Re: Request to Designate the Vivian Sand Extraction Project Based on Missing and Misleading Information in the Vivian Sand Extraction EAP and the Hydrogeology and Geochemistry Assessment Report prepared by AECOM Canada Ltd.

**Questions for CanWhite Virtual Open House for the Vivian Sand Extraction Project
and Hydrogeological Report
by D.M. LeNeveu B.Sc. (hons. physics) M.Sc. (biophysics) B.Ed.
Aug. 20, 2021**

Figure 2. Slumping of sand pillars leading to subsidence between well clusters. Figure 2-3 from the CWS EAP was modified for this figure.

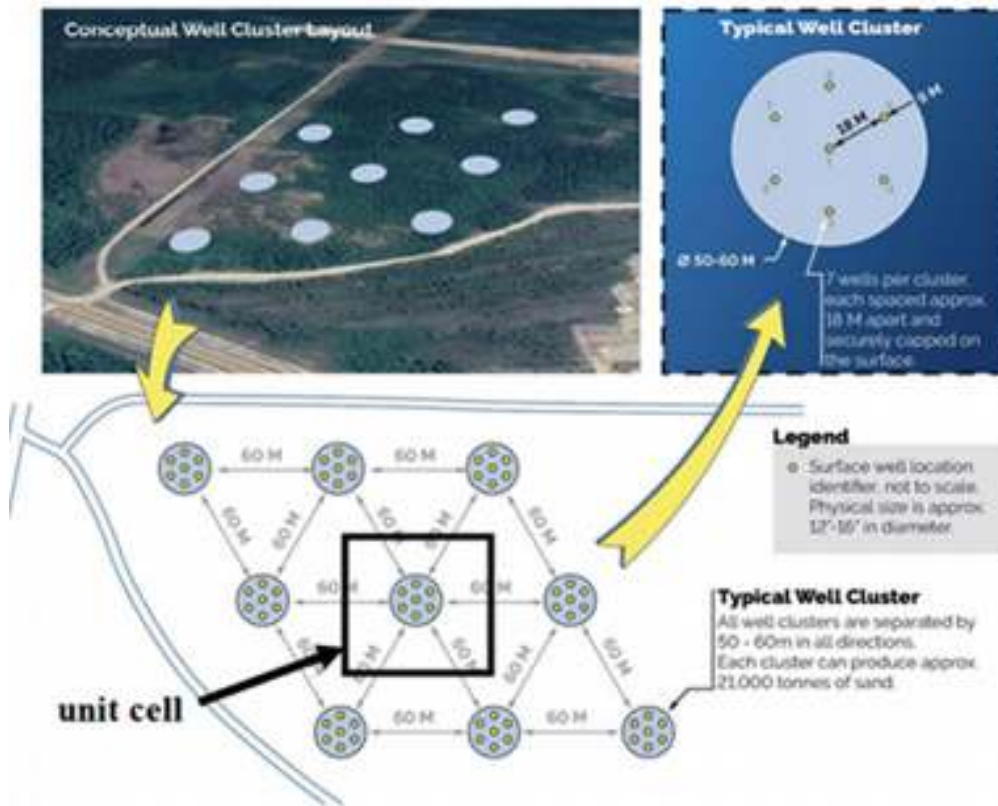
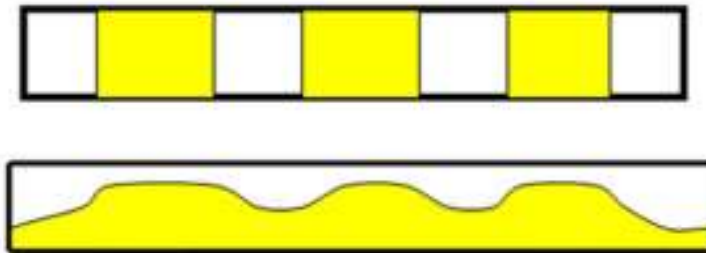
Sand slumping will enlarge the cavities under the well clusters creating an ever more unstable situation. Figure 2 illustrates the geometry of the well clusters and a unit cell within the clusters. The unit cell in figure 2 is 114 meters wide by 98.7 meters high with a central cavity of 54 meters in diameter. The extraction ratio in the sand layer for the unit cell shown is 0.203 (~20%). The unit cell and the 20% extraction ratio in the sand layer repeats as the clusters expand. The extraction ratio quoted in the EAP for the processing plant of 5% would include the layers of limestone and glacial till above the sand layer thus giving a much smaller extraction ratio.

As the sand slumps into the cavities the unsupported cavity area will increase as the extraction proceeds. Eventual collapse of the limestone and till and subsequent subsidence is inevitable over the entire area of the well clusters.

Figure 1. Limestone thickness in the carbonate aquifer of the CWS BRU extraction area.

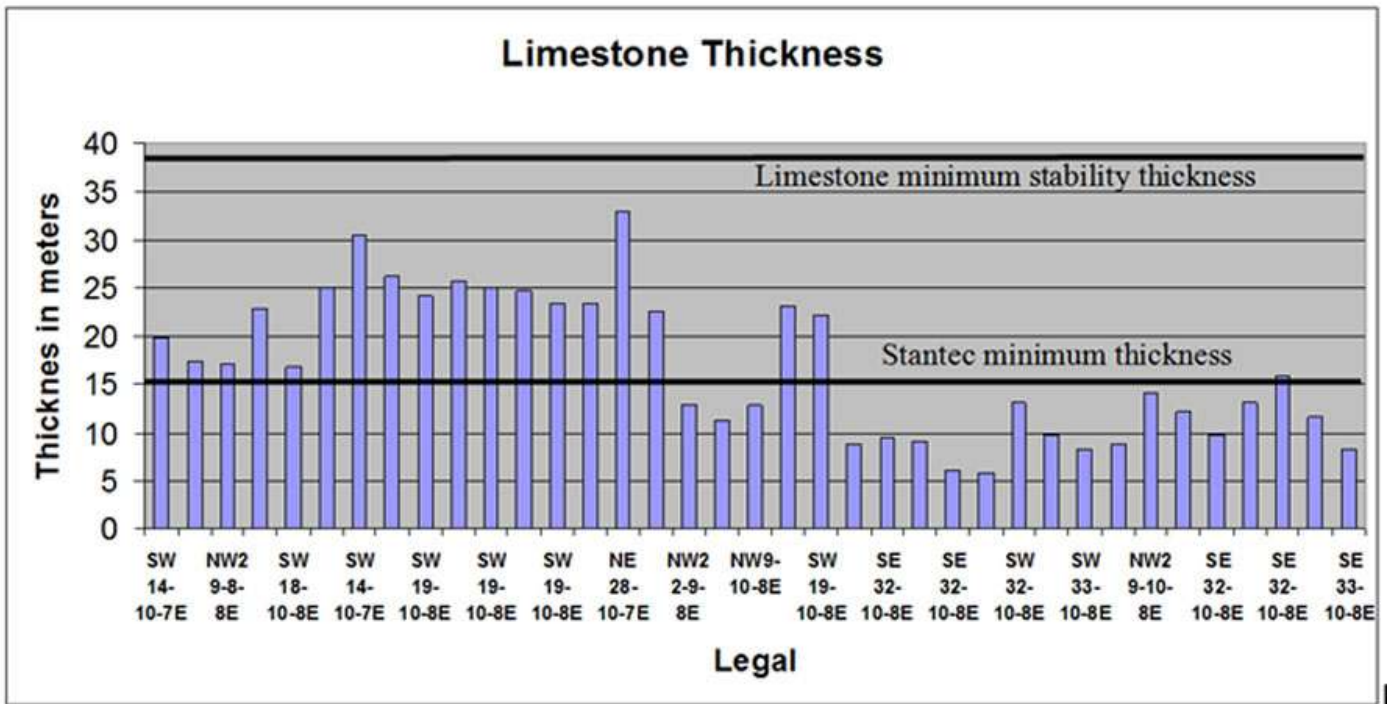
Figure 1 shows the limestone thickness of the carbonate aquifer in the Bru extraction area and the Stantec and Waltham and Fookes thickness limits. The data was taken from CWS well records supplied by Manitoba Groundwater and from the CWS borehole records in the hydrogeological report. The well records demonstrate that over the entire Bru extraction area all limestone thicknesses are less than the minimum criteria stated by Waltham and Fookes for stability. All limestone thicknesses in the eastern Bru area where extraction activities will begin are less than the Stantec limit of 15 meters. The limestone thickness in general increases westward.¹³

Will CWS move their operations westward into the ALY area where the limestone is thicker and the sandstone aquifer is saline to avoid subsidence?

Figure 3. Sinkhole development from CWS sand extraction²

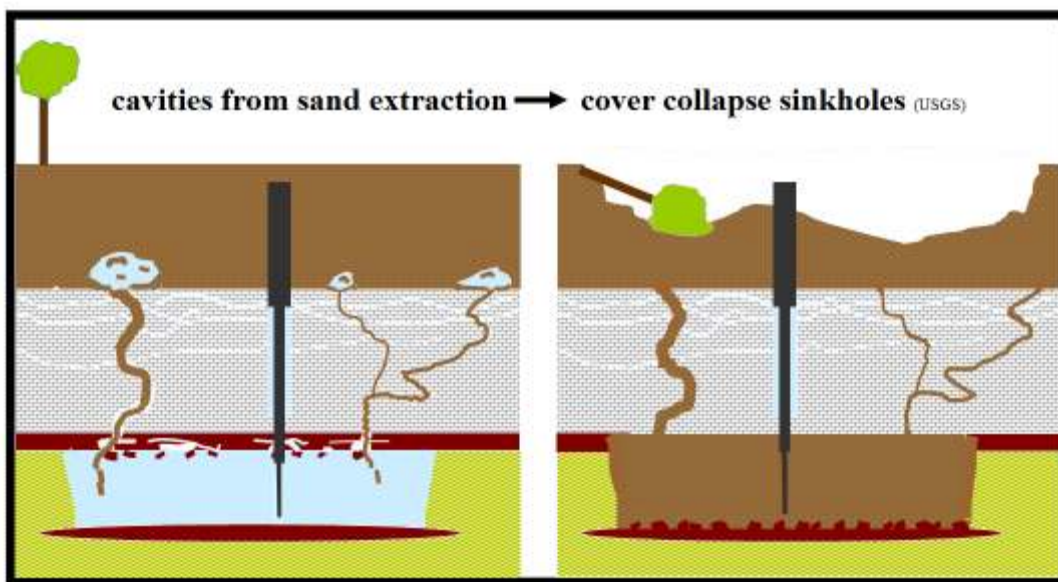
A report released by What the Frack Manitoba in February 2021, peer reviewed by A. Ingraffea of Cornell University a world renowned expert on geo-mechanics, determines the shale aquitard will be unstable and slake into the cavity from the sand extraction.²

The glacial till overburden will gradually migrate into the cavity through the compromised limestone layer causing a cover collapse condition. In cover collapse subsidence the cavity created in the till overburden by gradual migration through the limestone layer will suddenly collapse at some undetermined time in the future leaving a large sinkhole as illustrated in Figures 2 and 3. All of the well clusters created by CWS operations are susceptible to cover collapse. A moonscape of water filled sinkholes will be eventually created. Water contaminated iron bacteria, fecal coliform from septic fields and animal feces, other microbes, and chemicals from surface runoff will have direct access to the carbonate aquifer and the sandstone through the compromised shale aquitard. This subsidence scenario is untenable.

Figure 4. CWS 24 year project area overlaid on the map of the extent of the Carman sands (green speckled area) south of Vivian MB.

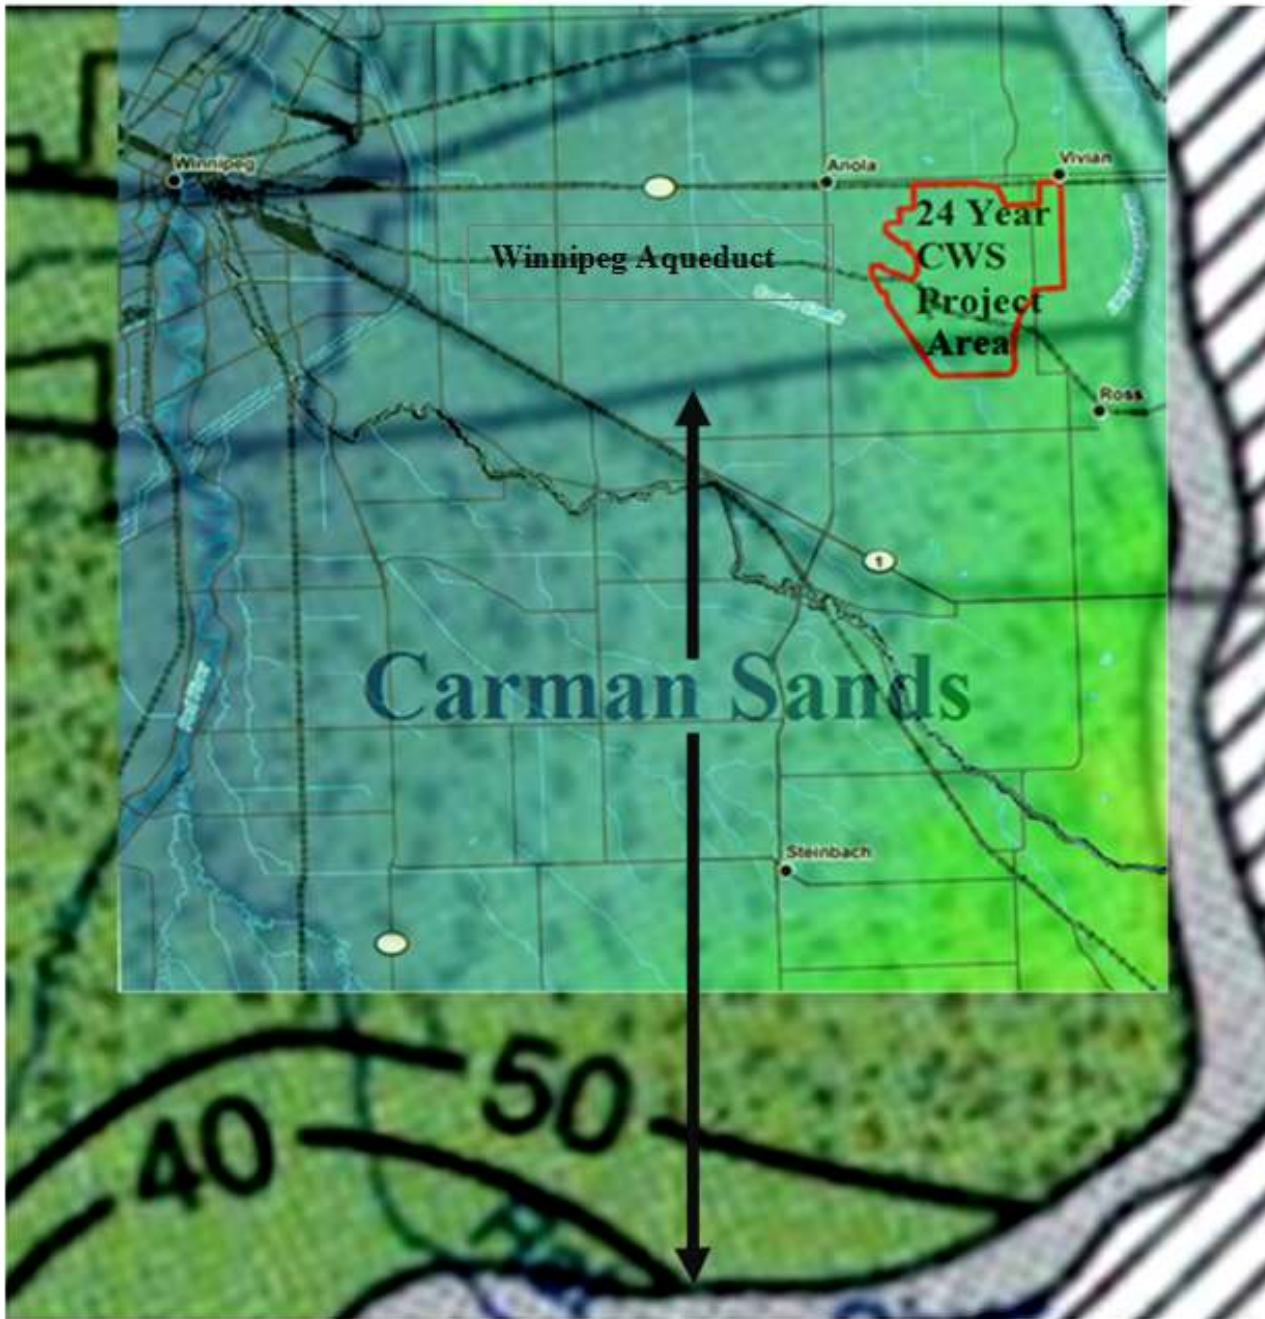
The above quote states the Carman Sands are below the Sandilands area. Figure 4 shows the Carman Sands as determined from the Manitoba Energy and Mines Bedrock Geology Compilation Map Series ¹³ overlaid on the CWS 24 year Project area. Figure 4 clearly shows only very southern portion of the project area is within the Carman sands.

Does CWS acknowledge the northern part of the BRU project area is wholly within the Black Island member part of the Winnipeg formation known to contain pyritic shale, marcasite coating the sand, pyritic concretions such as oolite layers and not within the Carman sands area?^{10,12,14,15} Does CWS acknowledge that the Black Island member from which sand will be extracted in the northern portion of the Bru area contains pyrite that will be exposed to re-injected aerated water that will form acid and mobilize heavy metals and selenium thereby contaminating the aquifer?
